PLANNING CONSULTATION BY LONDON BOROUGH OF TOWER HAMLETS

ORCHARD WHARF, ORCHARD PLACE, POPLAR, LONDON, E14 0JY.

SUMMARY

Dockside Buildings A and F proposed at 20 storeys

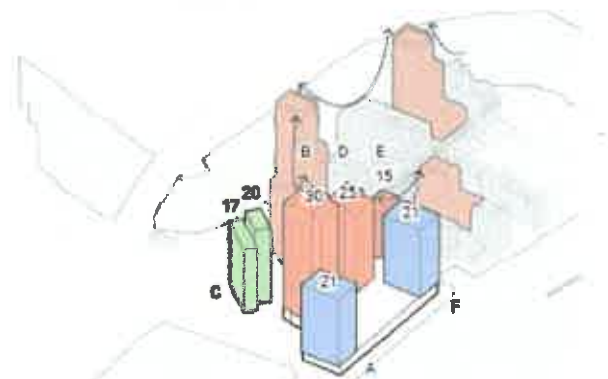
- a) the height, mass and combined design treatment of blocks A, B and C and the proposal to lower the development alongside the Basin thereby reducing the impact of the residential blocks on the open, waterside character of the Basin;

- 49 In relation to the Basin and its flat and open landscape, the heights of Blocks A, B and C appear out of proportion and dominate the Basin edge, the step down being much less obvious or distinct than the difference in storey height suggests. There is a sharp contrast between the smaller scale and more intimate space of the Basin and the combined bulk and mass of the 3 buildings. These dwarf the small woodland copse and the trees which sit alongside the Basin's eastern boundary. The combination of the width of building A when viewed from the Basin and the height of Building B are overbearing particularly for visitors to EIDB using the open space. Please refer to the images attached at Appendix D to this report. A more appropriate treatment would be for the development to be much lower alongside the Basin with substantial set back within Orchard Wharf providing a gentler transition – rising up towards the eastern and northern points of the site. This would accord with the LBTH Local Plan policy D.OWS4 'Water Spaces' and D.OWS3 'Open Space and Green Grid Connections.'

Wider views showing proposed development adjacent to EIDB

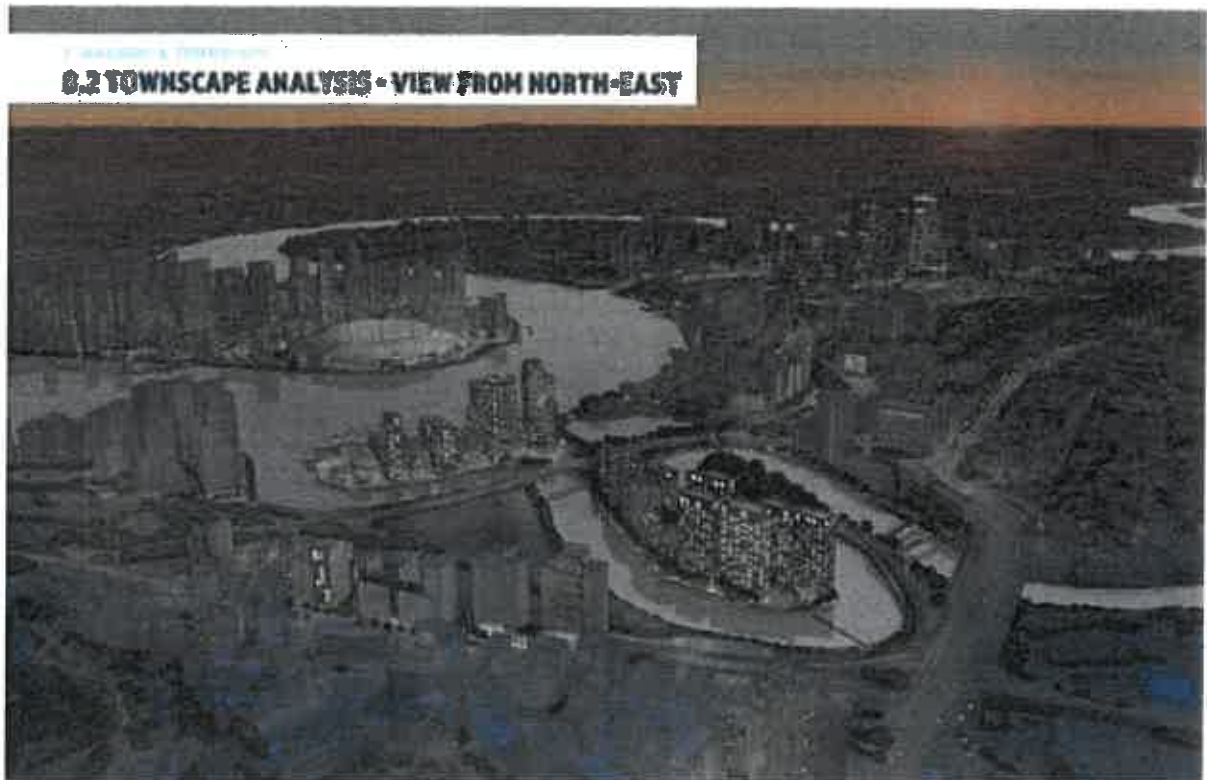
- 48 However, the relationship of the development to EIDB, is less successful. Its waterside edge and wider setting, including the more modest height of the residential areas such as Virginia Quay (at a maximum of 5 storeys) on the western side of the Basin, does not appear to have been considered to the same extent. This is contrary to LBTH Tall Building Policy D.DH6 which seeks to ensure that development with tall buildings takes account of the character of their immediate context as well as the wider surroundings and does not adversely impact on biodiversity and open spaces, including watercourses and water bodies.
